As per the approver comments, "all new steel columns to be center on the existing concrete column". However, structural framing plan graphically shows some of the NEW steel columns are offset from the center of existing concrete column,(see yellow clouded locations) from page #2 thru #6.
So we intend to move the all NEW yellow clouded steel columns (which is off from ex. concrete column center per structural drawing) to the center of existing concrete column and adjust the beam framing at all levels according to it.
Please advise. (See page #2 to #6 for the columns need to re-locate)

1250 Maryland Avenue
1250 MARYLAND AVENUE SW
WASHINGTON, DC 20024

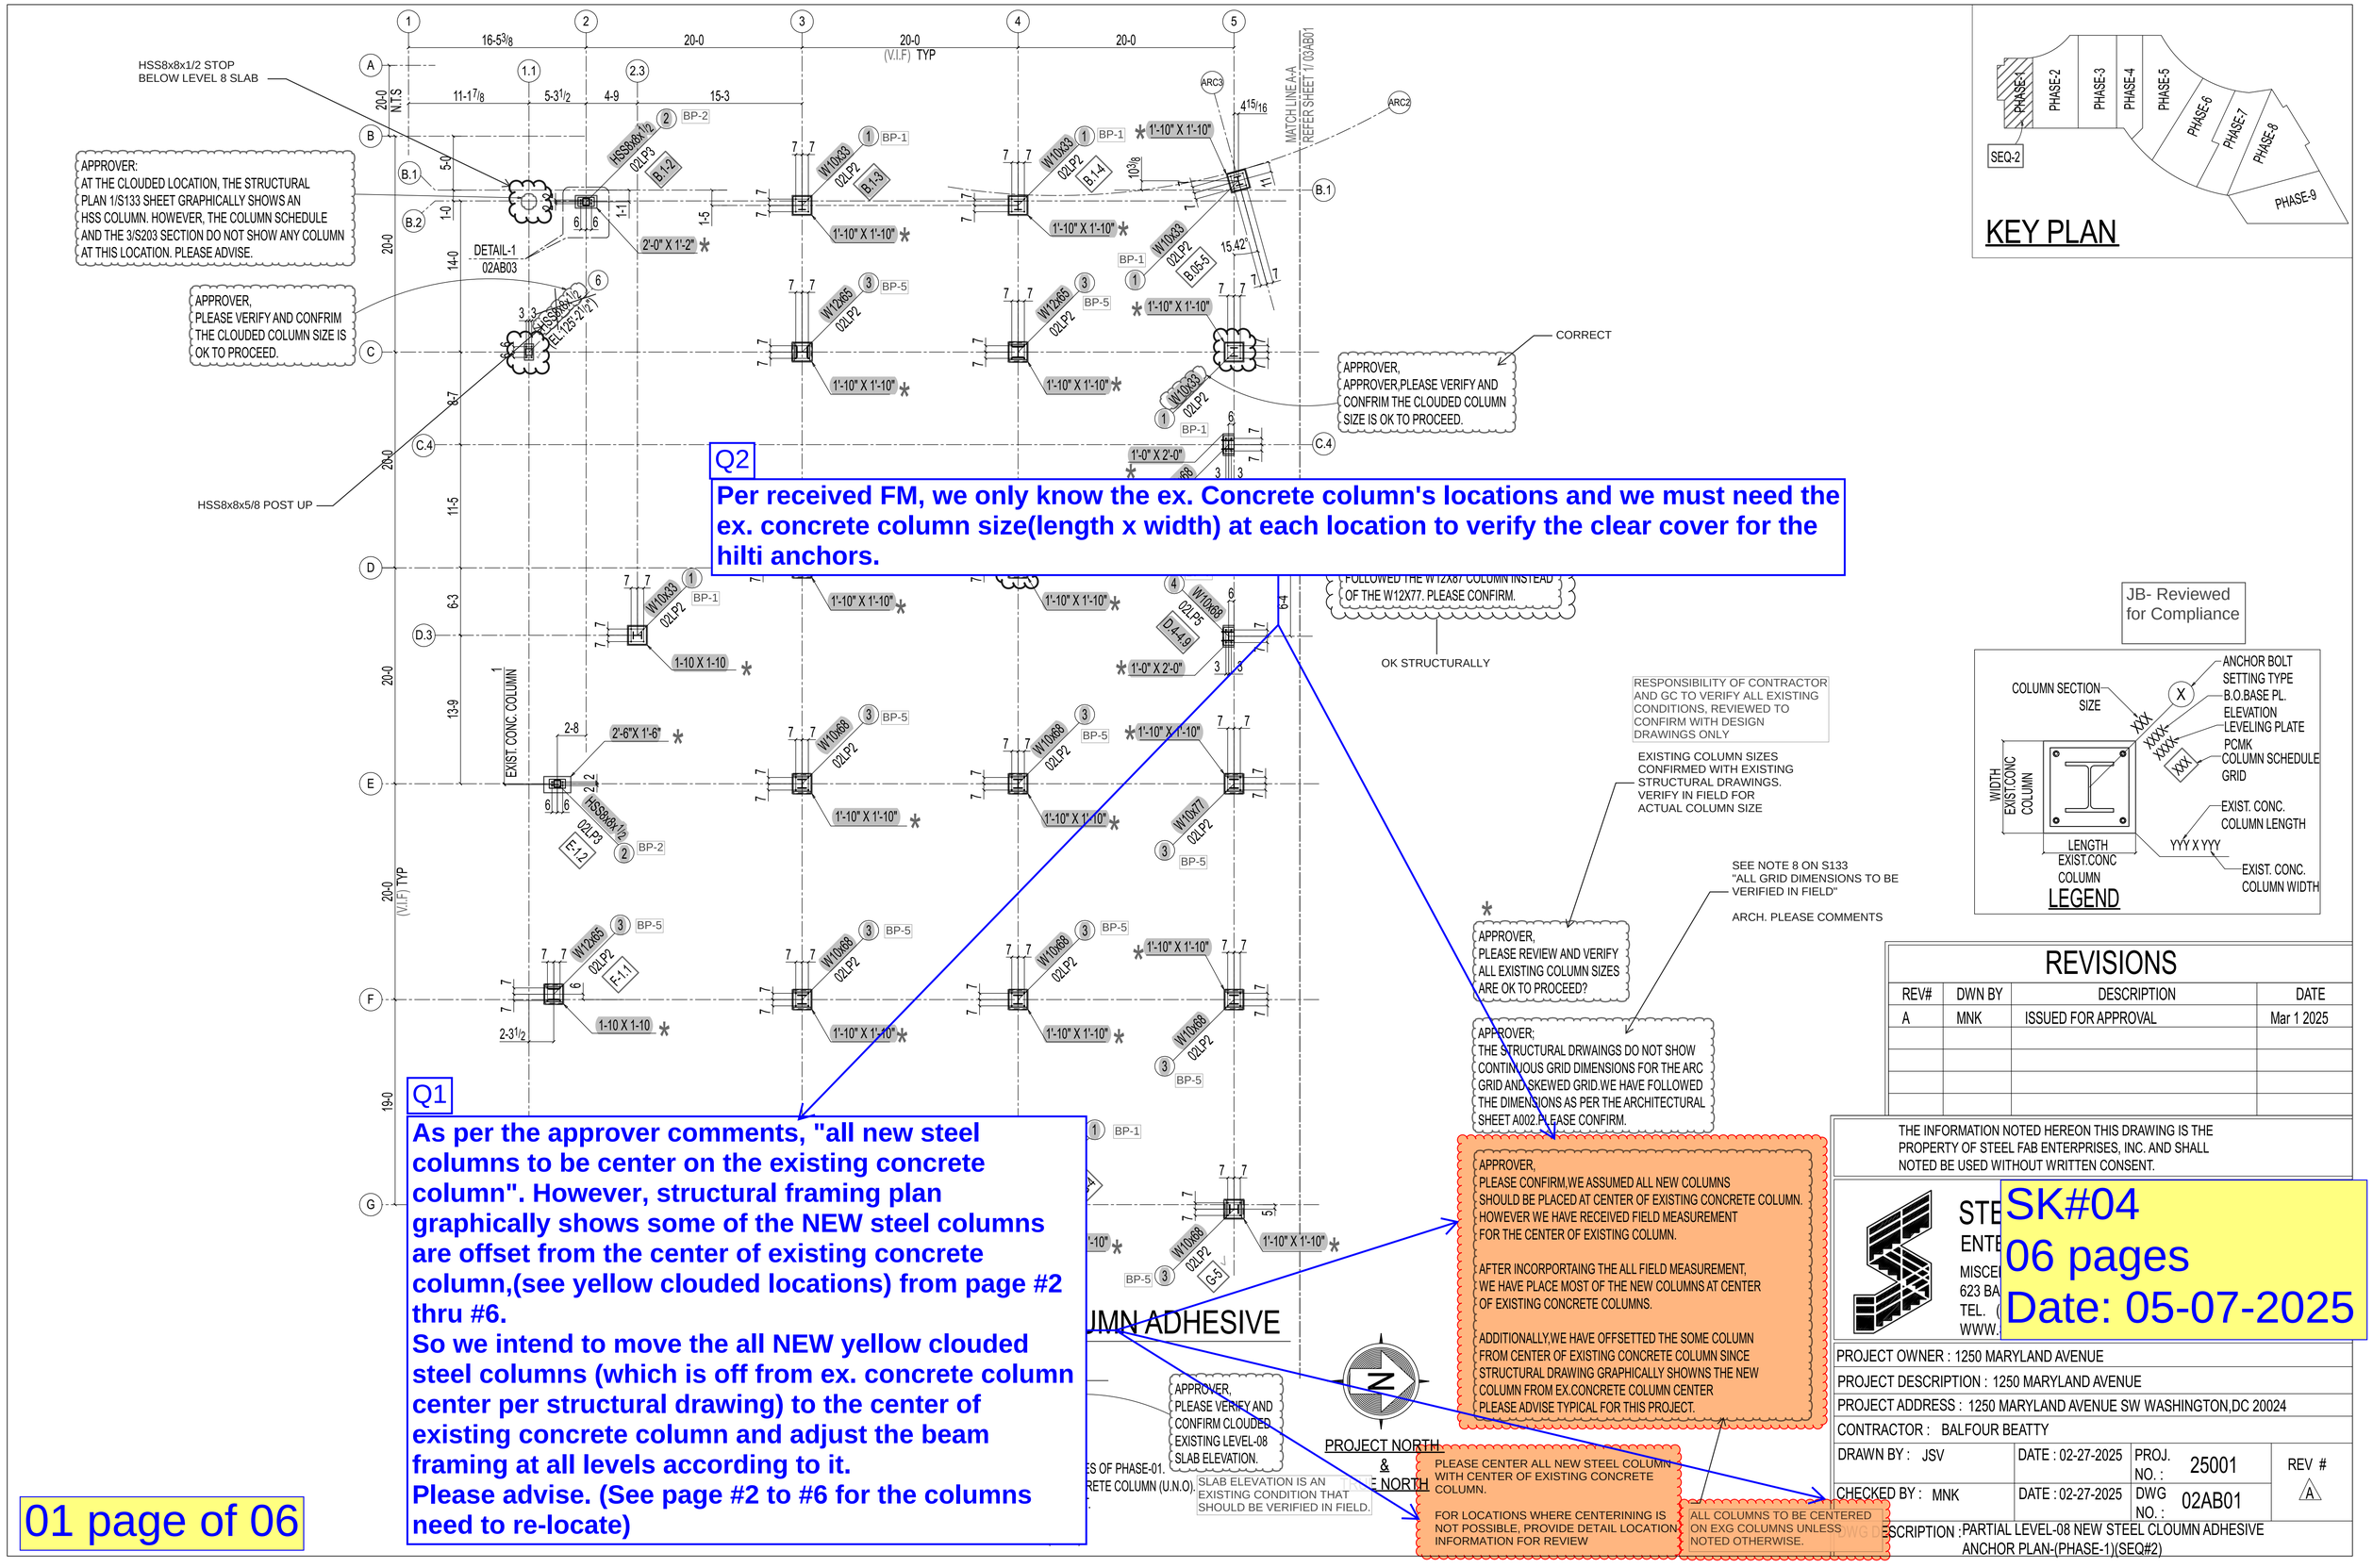
Q2

Per received FM, we only know the ex. Concrete column's locations and we must need the ex. concrete column size(length x width) at each location to verify the clear cover for the hilti anchors.

Q1
